STANDARD DEPARTURE CHART-INSTRUMENT

RJFN / NYUTABARU

NIPPO SEVEN DEPARTURE

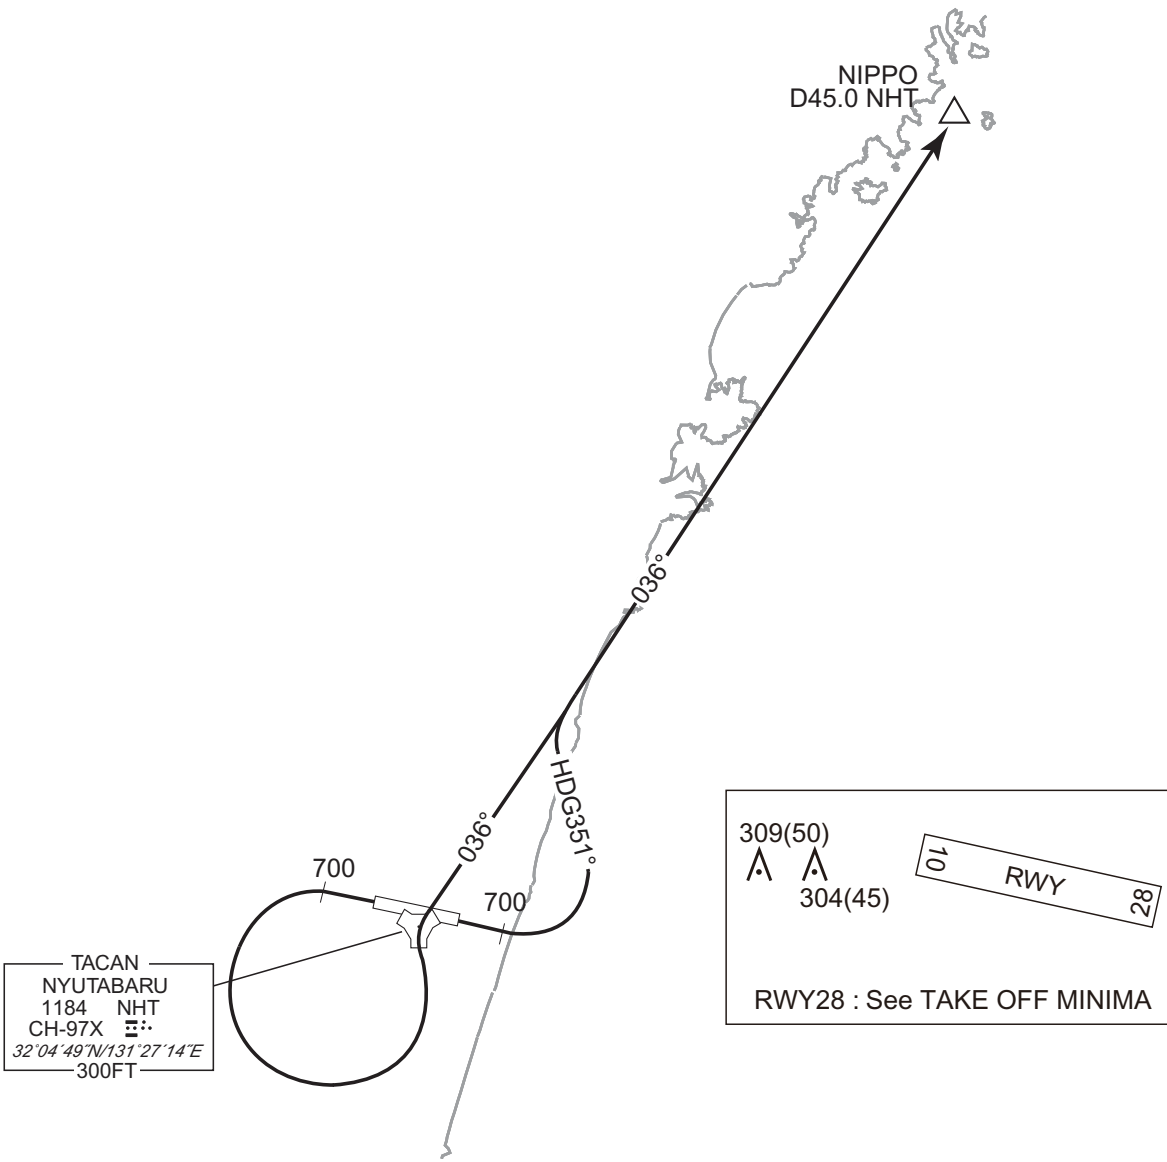
CHANGE : PROC renamed(NIPPO SEVEN DEPARTURE). PROC course(NIPPO SEVEN DEPARTURE). YATOJI TWO DEPARTURE abolished.
Restriction. Note, OBST added.

RWY10 : Climb RWY HDG to 700FT, turn left HDG 351°...

RWY28 : Climb RWY HDG to 700FT, turn left...

...to intercept and proceed via NHT R036 to NIPPO.

Note RWY28 : 5.0% climb gradient required up to 4000FT.

SAITO ONE DEPARTURE

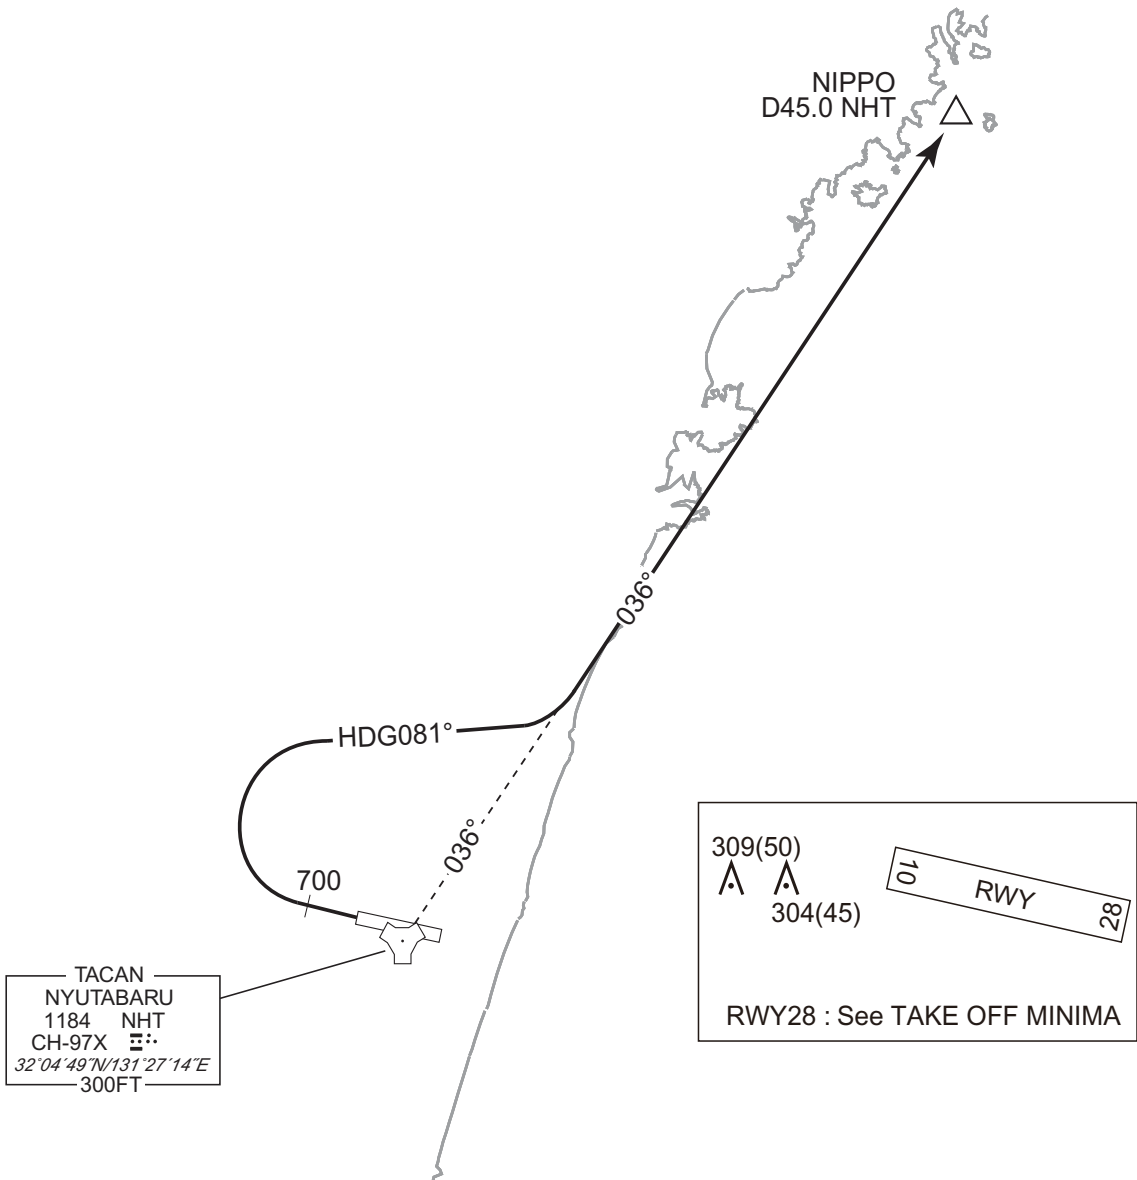
CHANGE : New PROC.

- RWY10 : (Not established)
- RWY28 : Climb RWY HDG to 700FT, turn right HDG 081° to intercept and proceed via NHT R036 to NIPPO.

Note RWY28 : 5.0% climb gradient required up to 4000FT.
OBST ALT 1871FT located at 6.3NM 334° FM end of RWY28.

TRANSITION

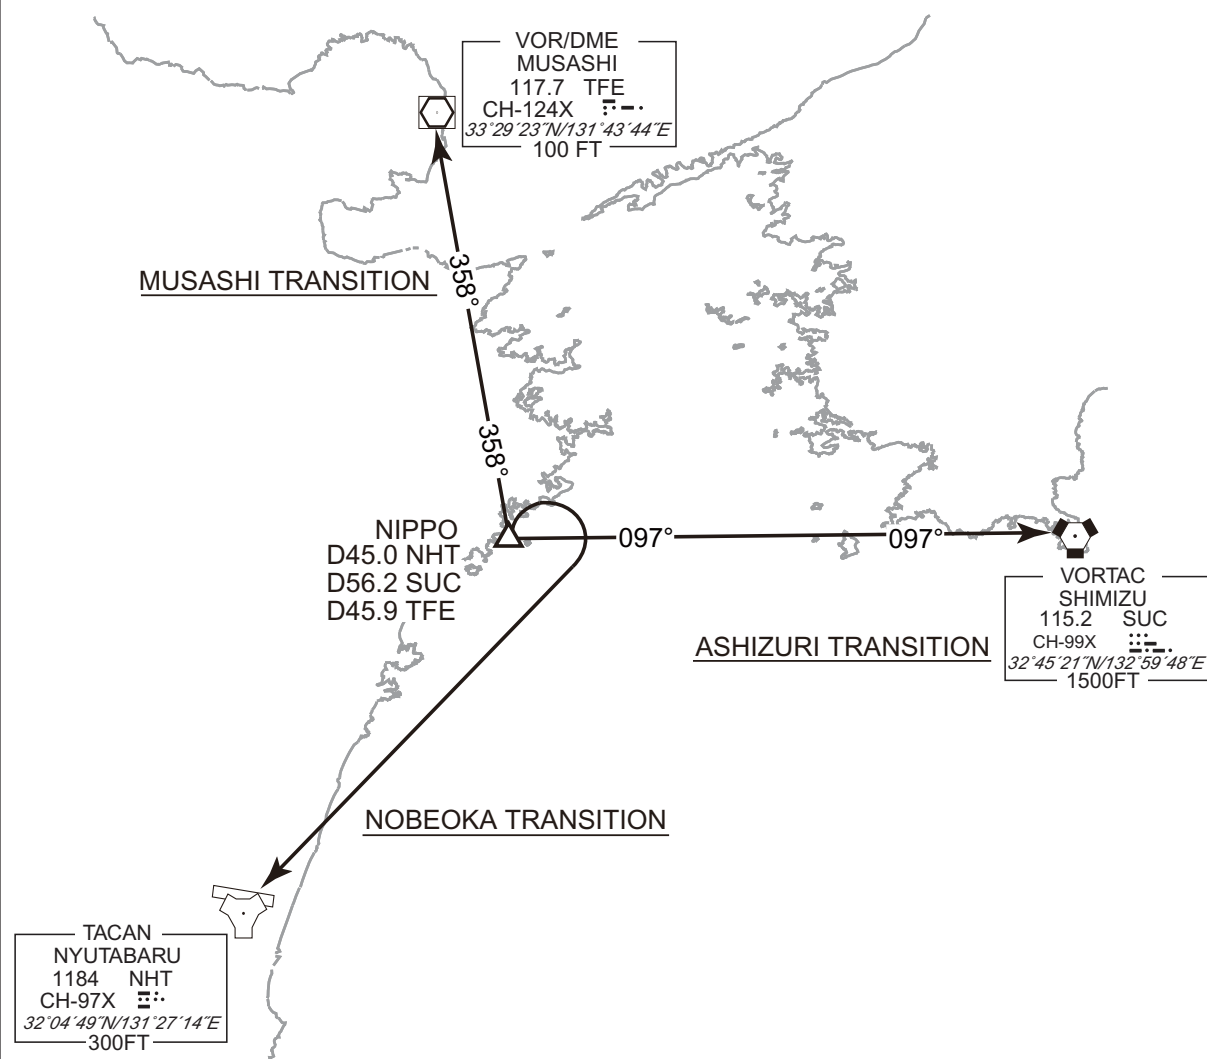
CHANGE : PROC course(NOBEOKA TRANSITION). Description of ASHIZURI TRANSITION, MUSASHI TRANSITION, MUSASHI TRANSITION. ALT restriction.
SOBO TRANSITION abolished.

From over NIPPO, via SUC R277 to SUC VORTAC.

From over NIPPO, via TFE R178 to TFE VOR/DME.

From over NIPPO, turn right direct to NHT TACAN.

TENSO ARRIVAL

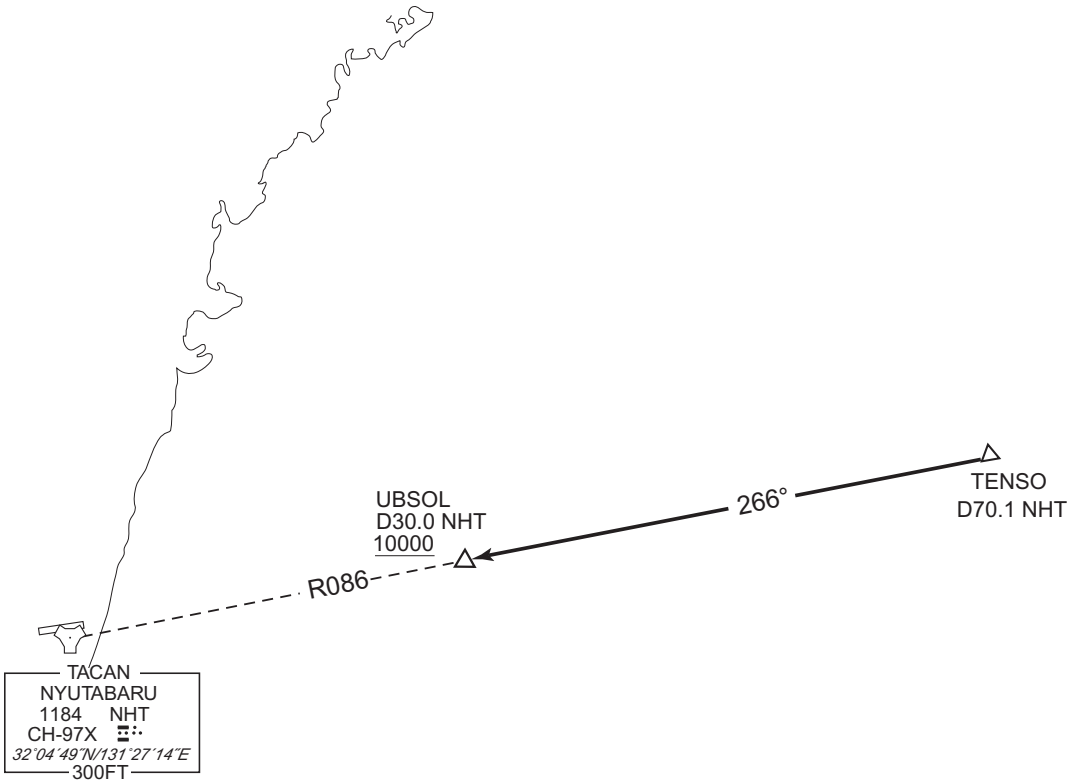
CHANGE : PROC course. UBSOL established. ALT restriction.

From over TENSO, via NHT R086 to UBSOL.
Cross UBSOL at or above 10000FT.

TACAN Z RWY28

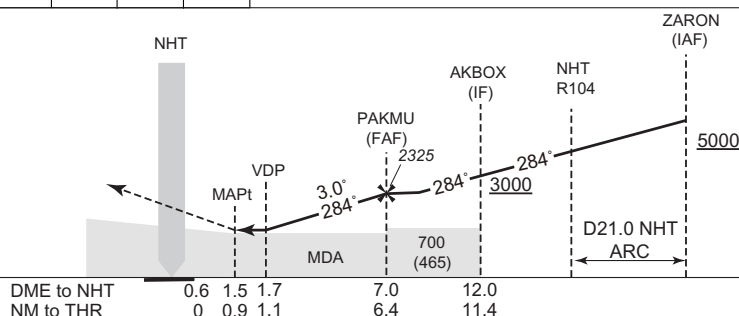
CHANGE : PROC course. Missed APCH course. MINIMA. PAKMU,AKBOX established. NM to THR. ALT(3.0°APCH Path), DME to NHT added.
Missed APCH climb gradient MNM added. VAR.

Climb to 700FT on HDG 284°,
turn right HDG 111° to intercept
and proceed via NHT R066 to
ZARON and hold at 5000FT.
Contact KAGOSHIMA APP.

Missed APCH climb gradient MNM 3.0%

INSTRUMENT APPROACH CHART

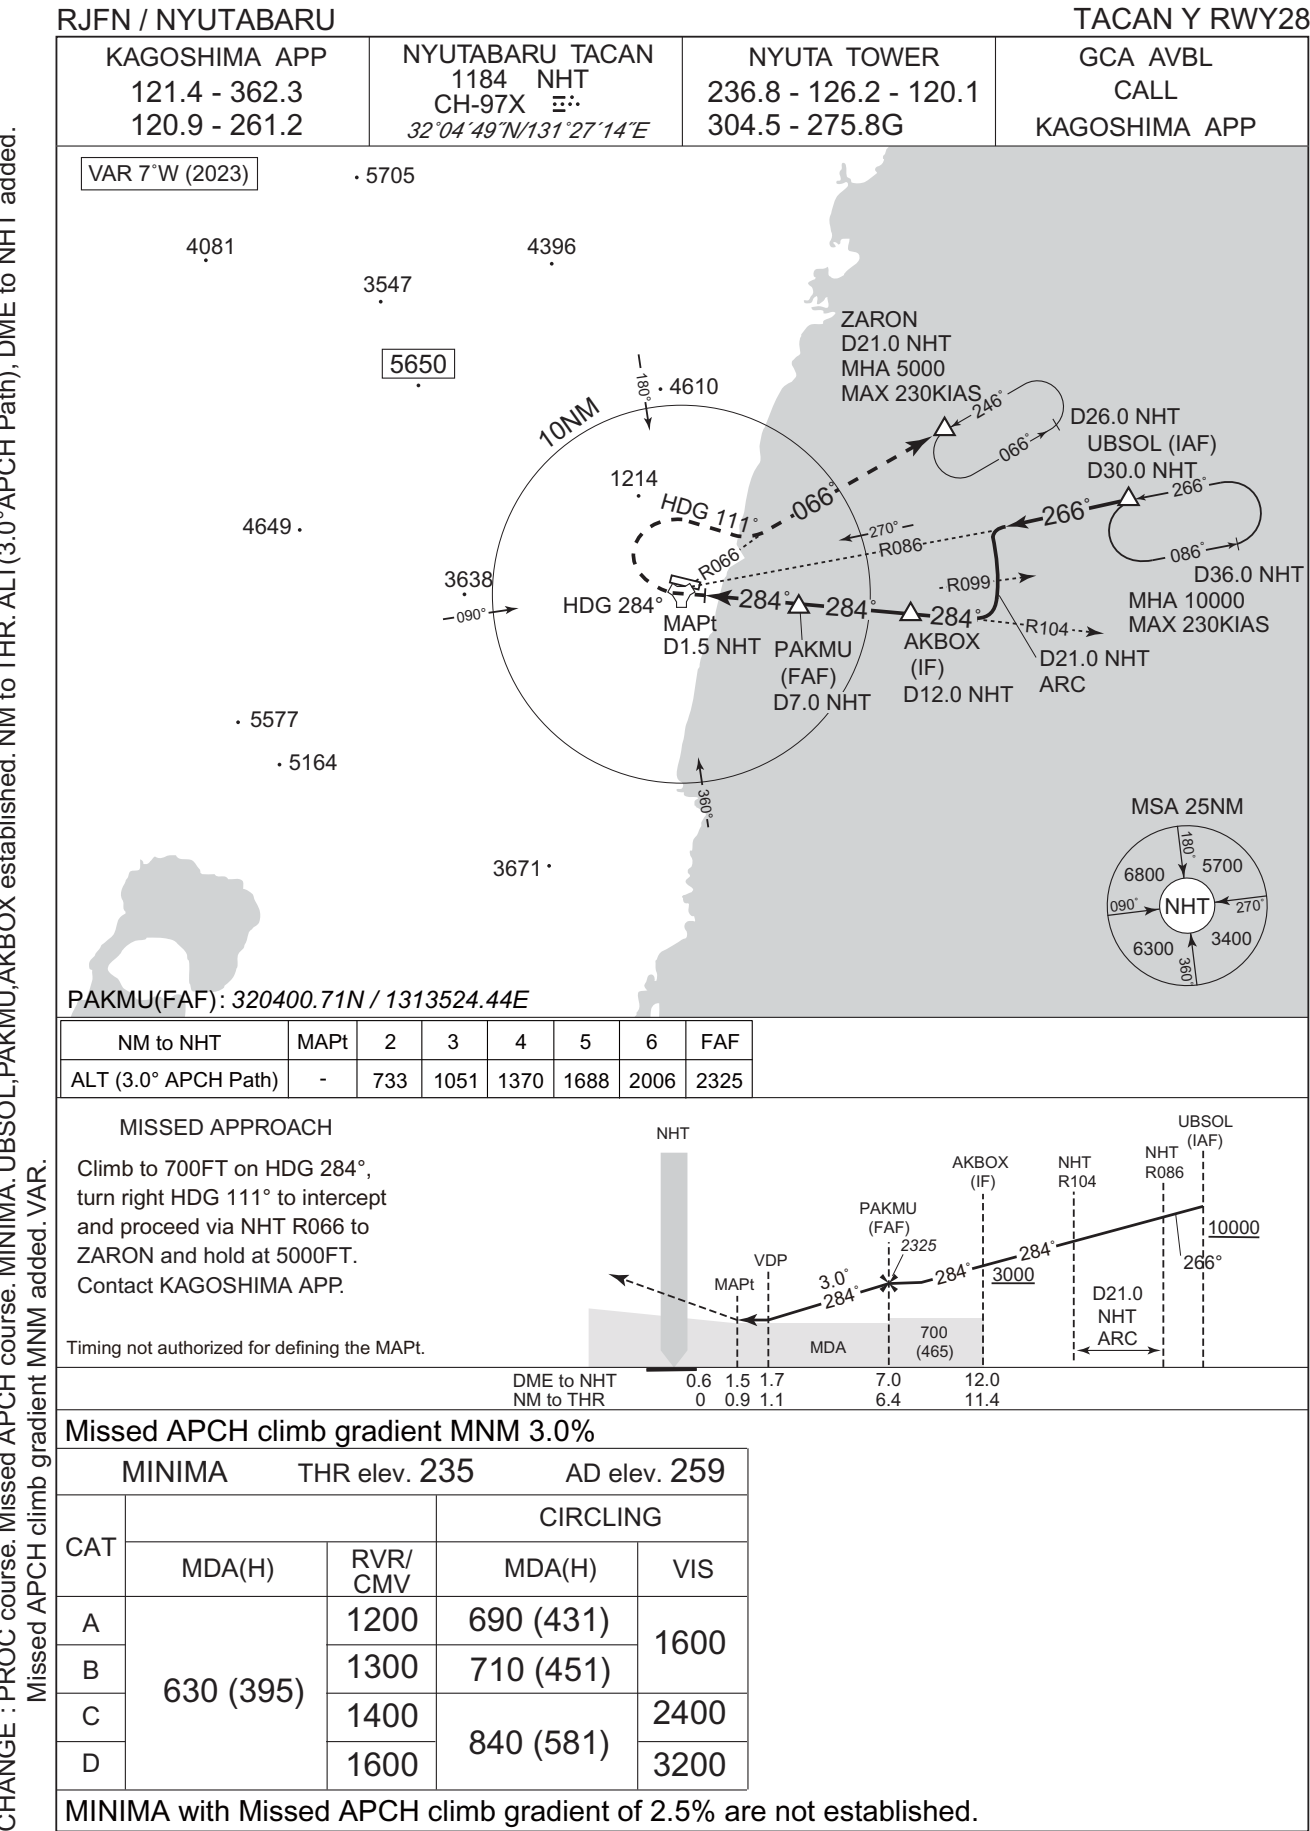
CHANGE : VAR. PROC renamed. EQPT REQUIRED added. PROC course. MISSED APPROACH course. MSA.
NM to THR added. MDA(H) for CIRCLING.

INSTRUMENT APPROACH CHART

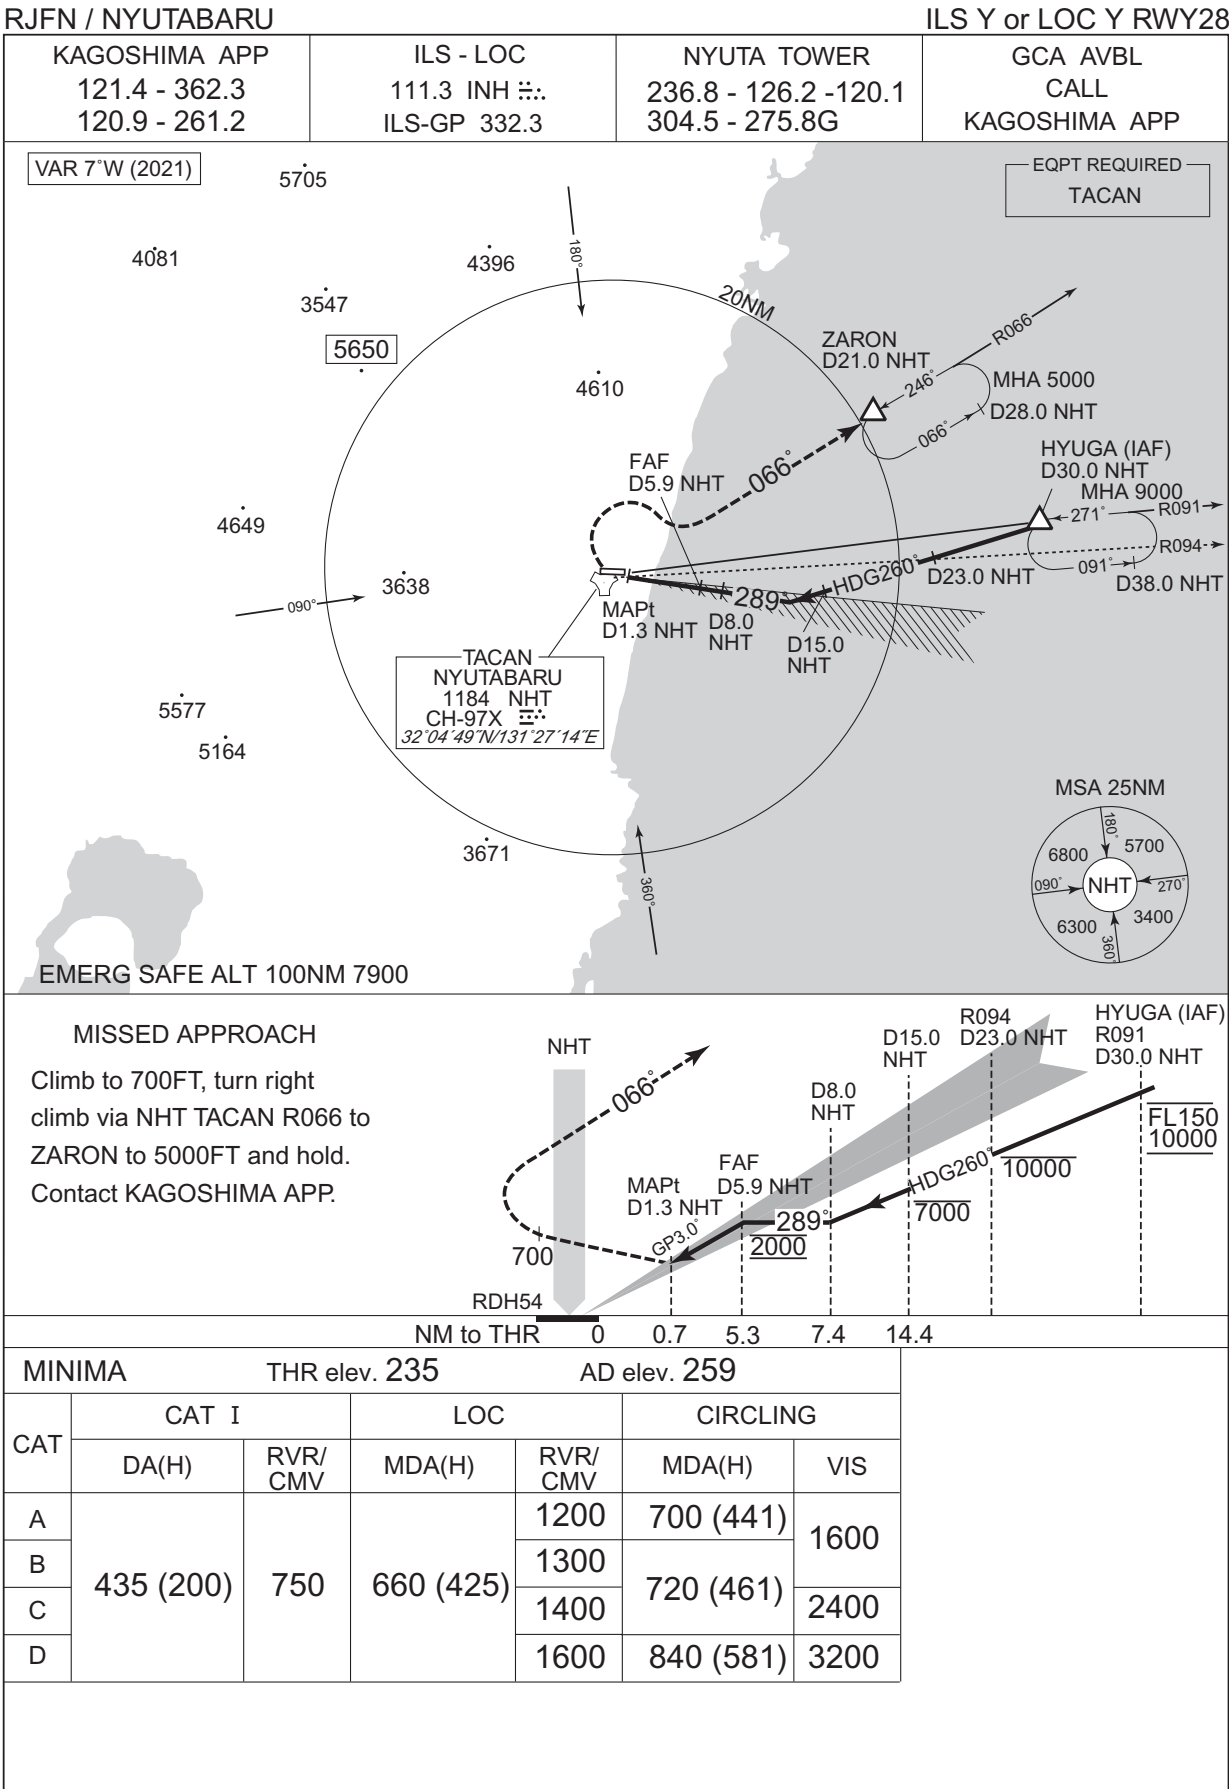
CHANGE : VAR. PROC renamed. EQPT REQUIRED added. PROC course. MISSED APPROACH course. MSA.
NM to THR added. MDA(H) for CIRCLING.
